**PCD-ENGINEERING REVIEW COMMENTS
IN BLUE BOXES WITH BLUE TEXT**

Engineering Review

**FALCON FIELD
PRELIMINARY DRAINAGE REPORT
EL PASO COUNTY, COLORADO**

Please add PCD File No.
SP21-001

DETENTION BASIN STAGE-STORAGE TABLE BUILDER

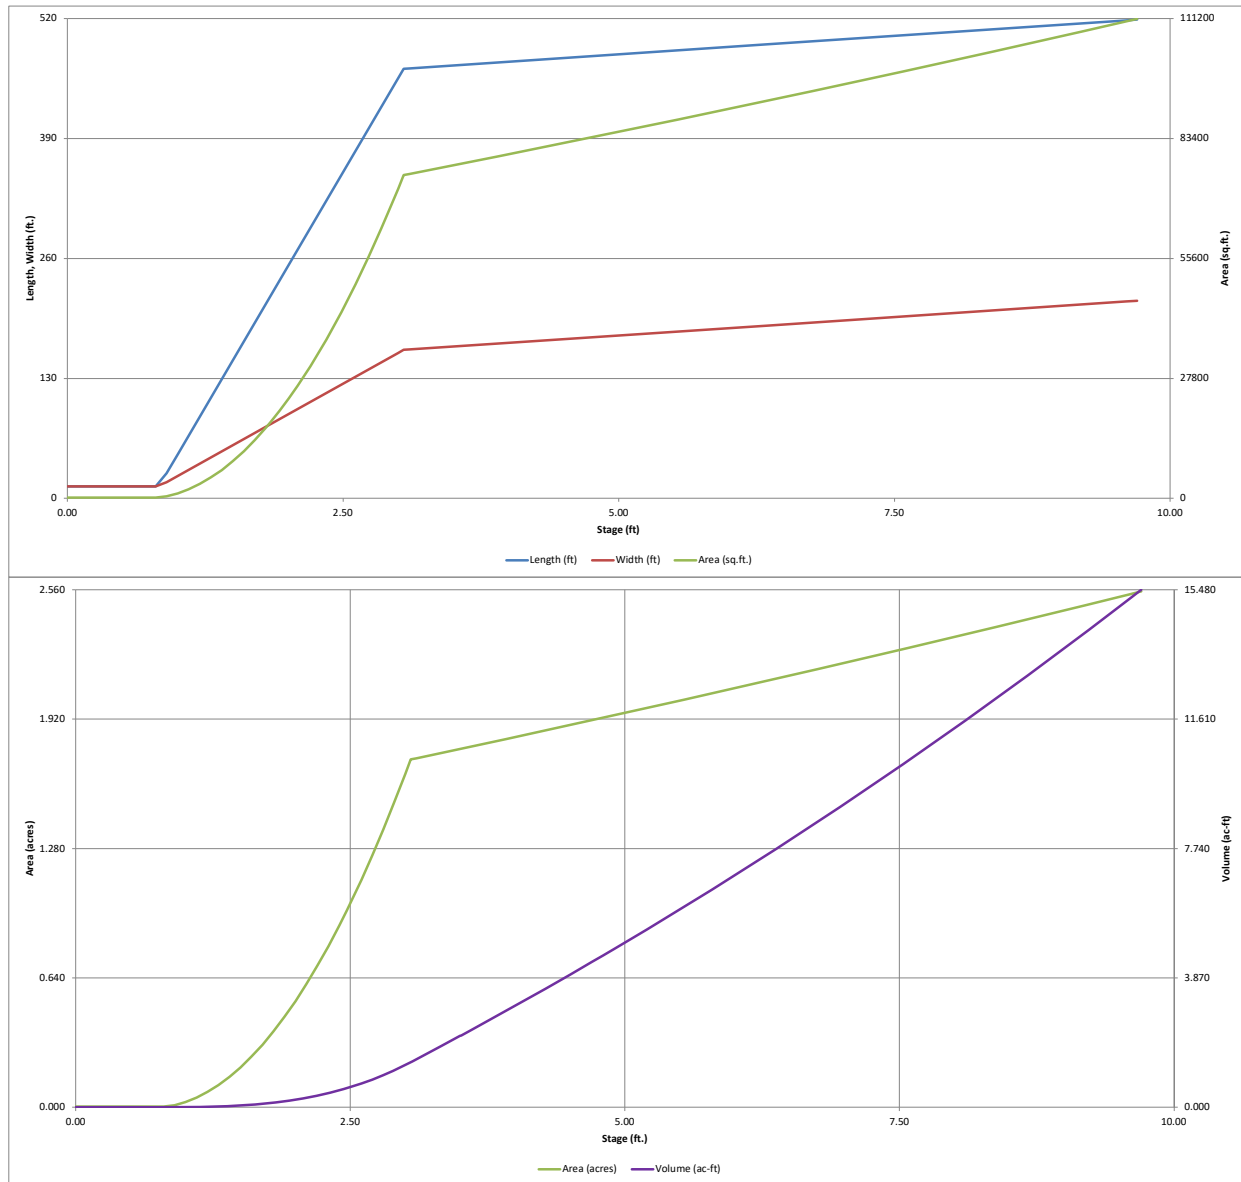
Per your narrative Basins D1, 2, 4, 5, 6, 8 & 9 are tributary to this pond. Revise the area accordingly.

PROJECT FALCON FIELD
SHEET TITLE EXISTING DRAINAGE MAP
FROM N/A TO N/A
JOB NO. 14-08 SHEET 1 OF 1

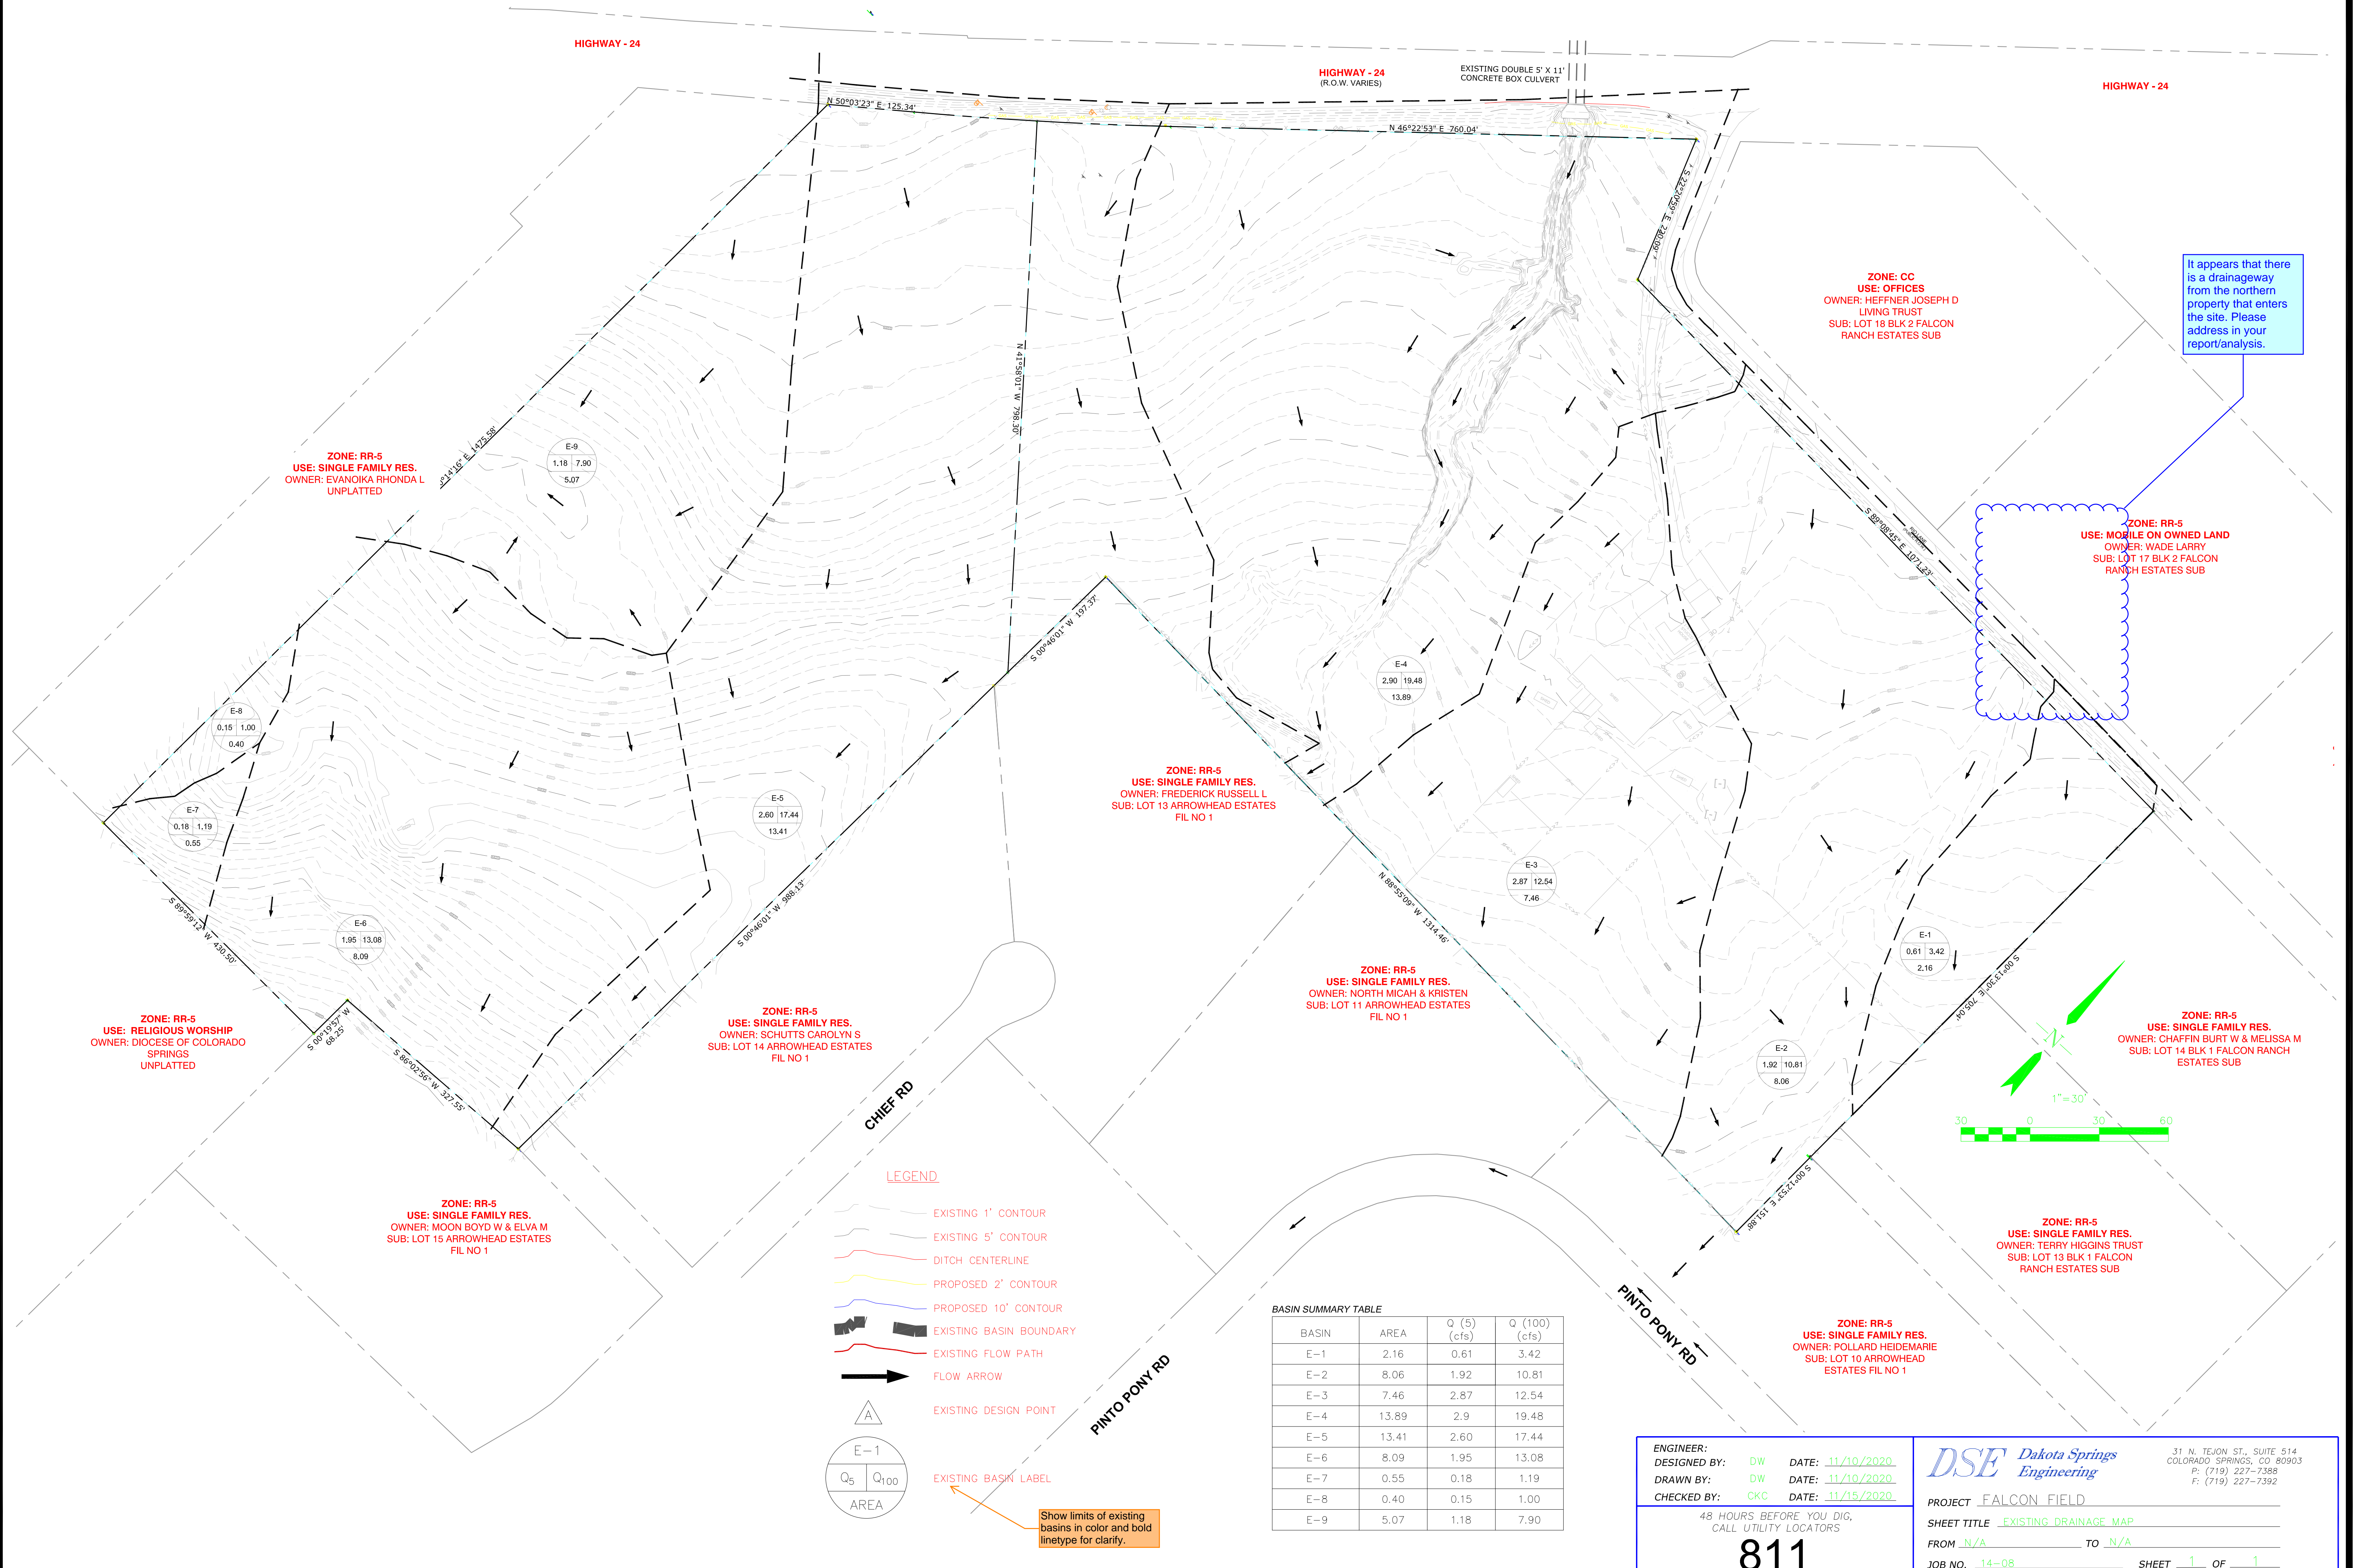
There appears to be runoff from the property to the north that enters this basin. Please be sure to account for it in your design. See comment in the existing drainage plan

Show limits of existing basins in color and bold linetype for clarity.

PROJECT: FALCON FIELD
SHEET TITLE: PROPOSED DRAINAGE MAP
FROM: N/A TO: N/A
JOB NO.: 14-08 SHEET: 1 OF 1

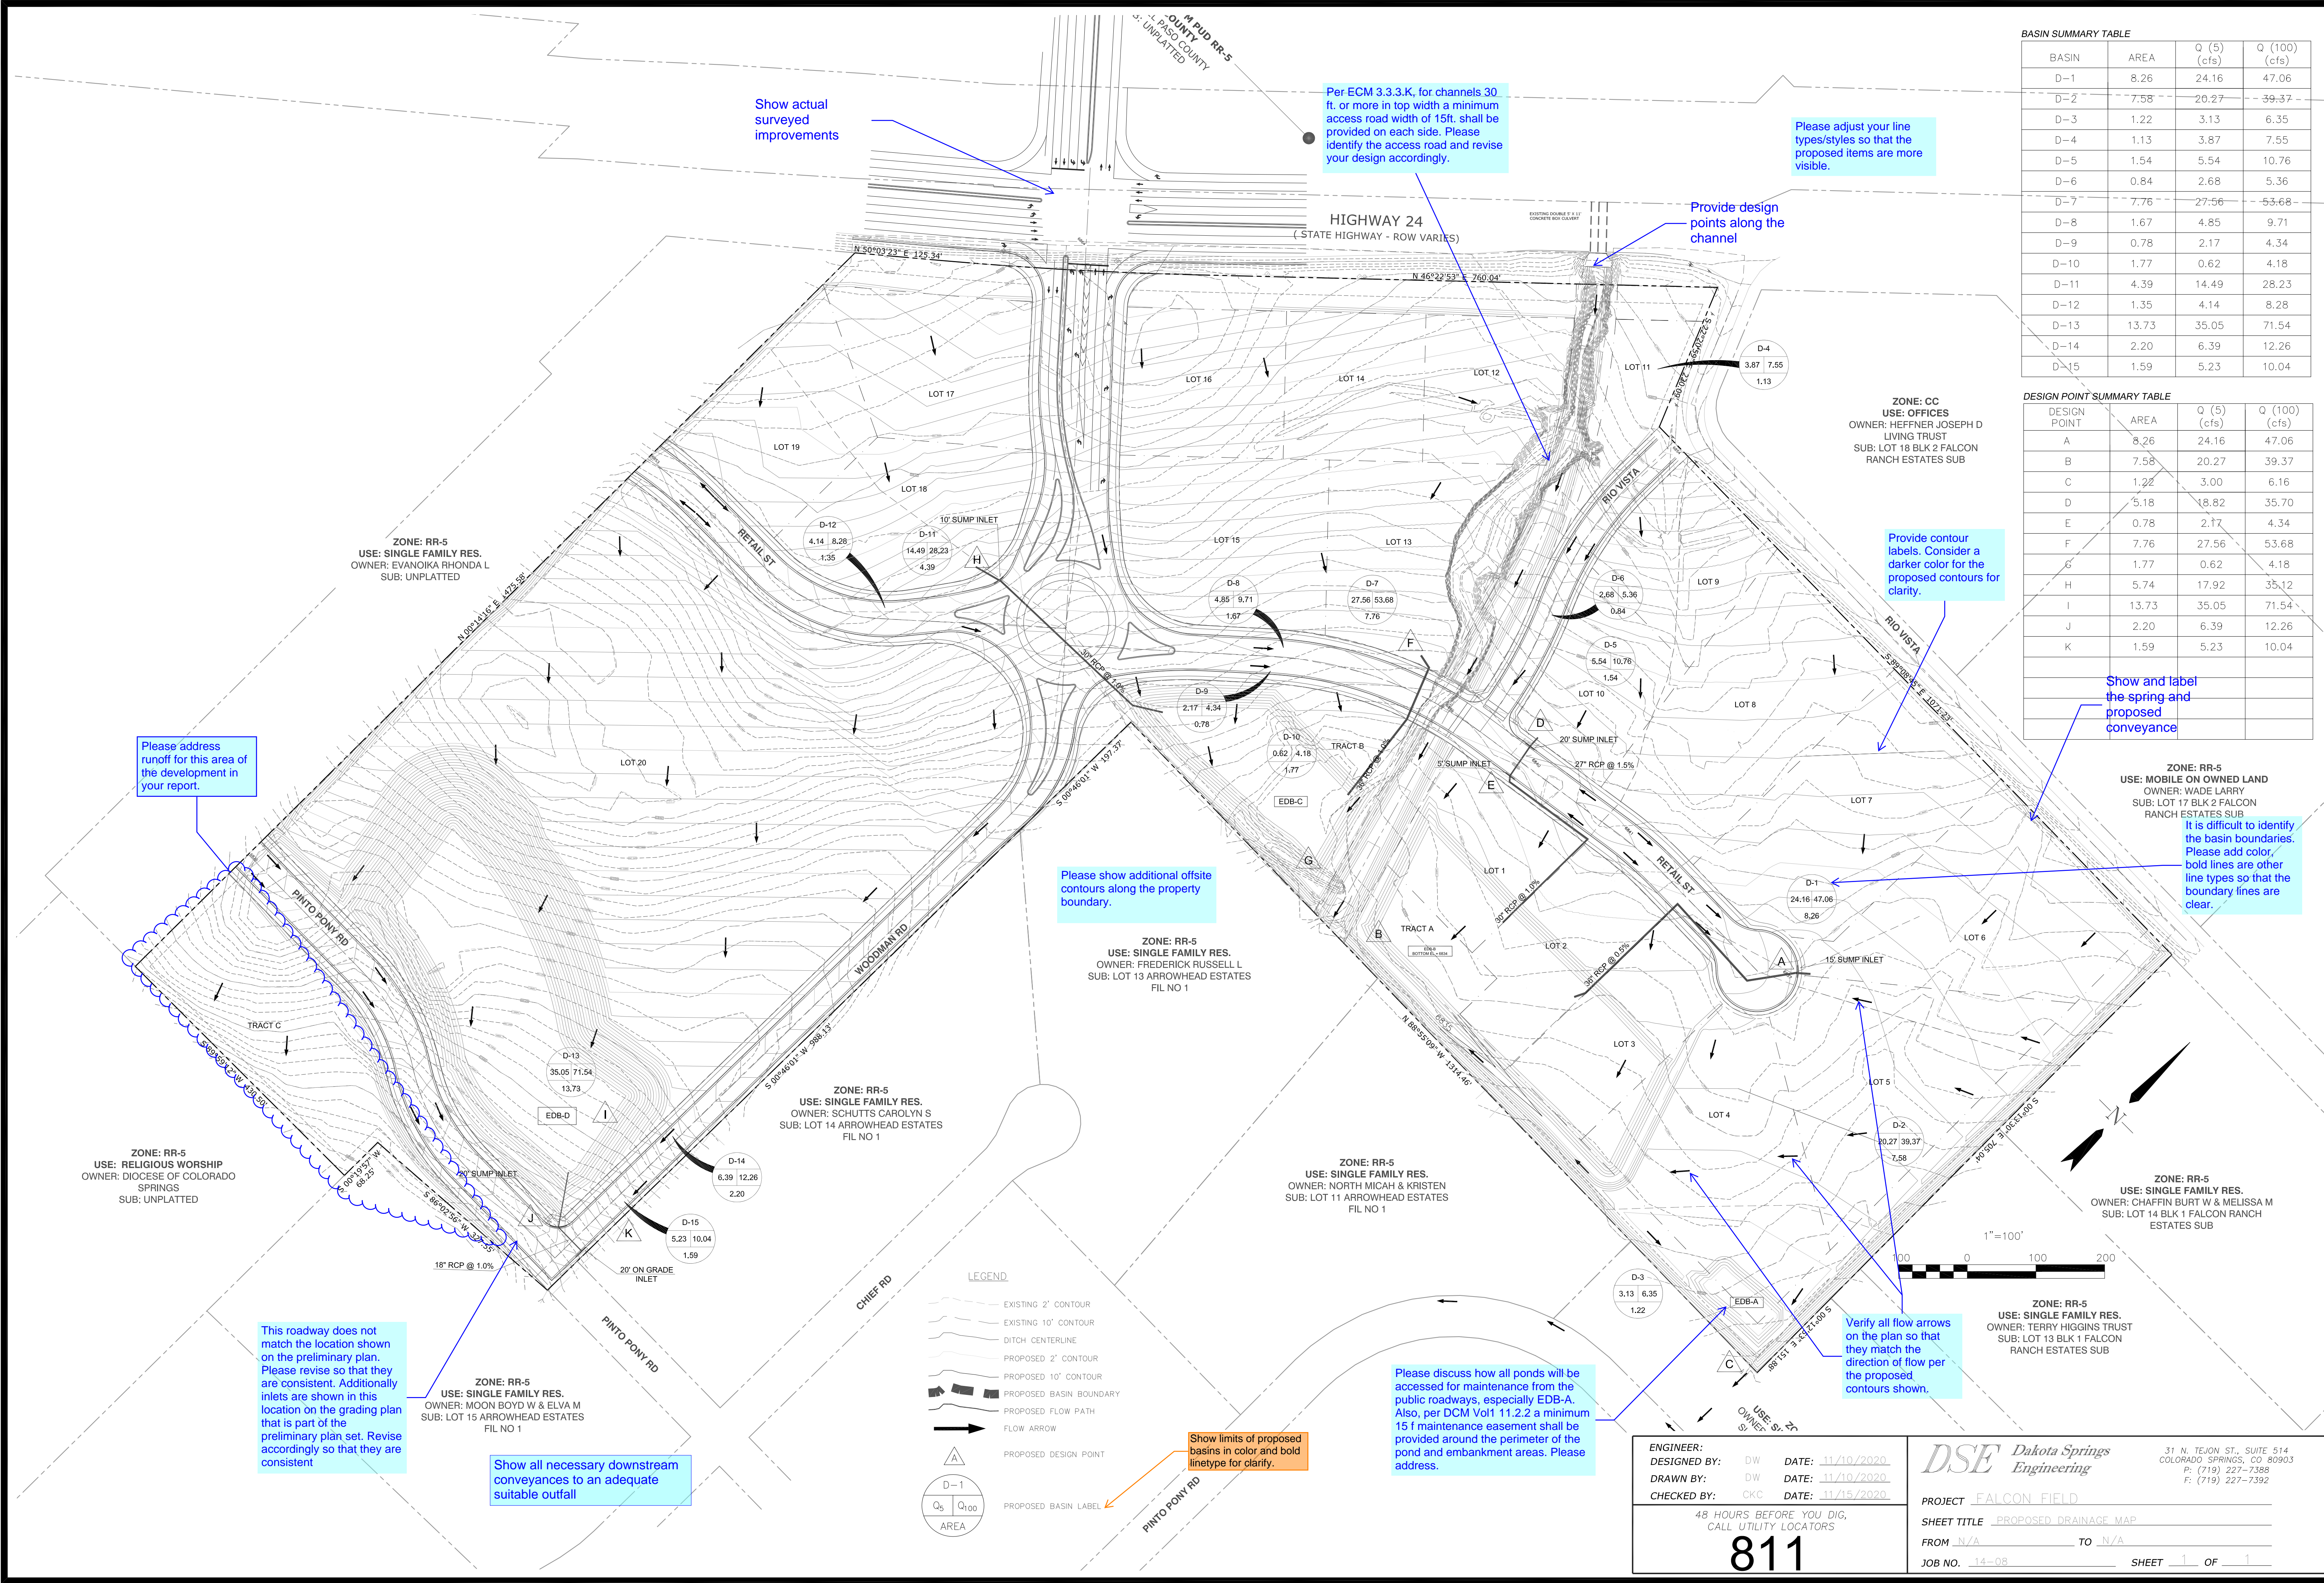
The flows shown do not match what is on the table on the proposed drainage map. Revise accordingly. Also, is DP B intended to be the outfall location of the pond? if so then please include that information in the text.

Basin A has not been identified on the plan. Revise accordingly.
